# Service Bulletin

**SB-10057651-9064**

**SUBJECT:** Service Update for Inventory and Customer Vehicles  
Incorrect Console Wiring  
Expires with Base Warranty

**MODELS:** 2015 Chevrolet Suburban, Tahoe  
2015 GMC Yukon, Yukon XL  
Equipped with Custom Front Floor Console without Cooler

4065612

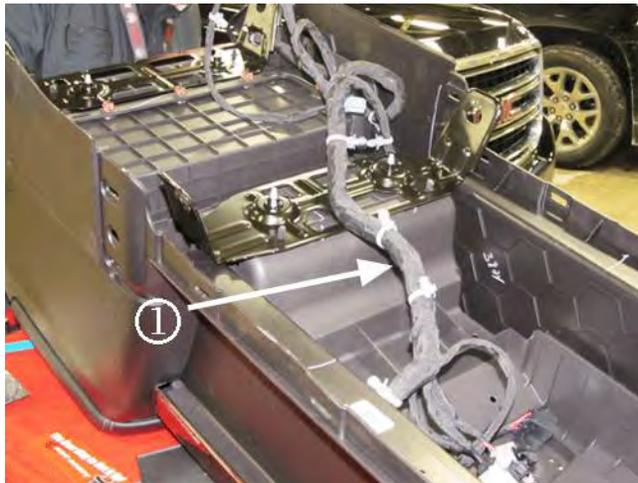
This bulletin provides a service procedure to replace the console-wiring harness on **certain** 2015 model year Chevrolet Suburban, Chevrolet Tahoe, GMC Yukon and GMC Yukon XL vehicles equipped with a custom front-floor console without cooler. These vehicles may have been built with an incorrect console-wiring harness which may cause the transfer case, child-door lock, window lock, heated-steering wheel, park assist and lane-departure switch indicators to not function. The heated seats function as intended, but because of the incorrect console harness, the battery-feed circuit to the heated-seat switches is protected by the wrong fuse and will not be properly protected if a short-circuit failure ever occurs.

**NOTE:** To help eliminate/minimize damage to the console molded tabs, use care when removing the original harness push fasteners.

1. Remove the front floor console wiring harness (1). Refer to *Front Floor Console Wiring Harness Replacement (Chevrolet / GMC)* in SI.
2. Install the new front floor console wiring harness. Refer to *Front Floor Console Wiring Harness Replacement (Chevrolet / GMC)* in SI.
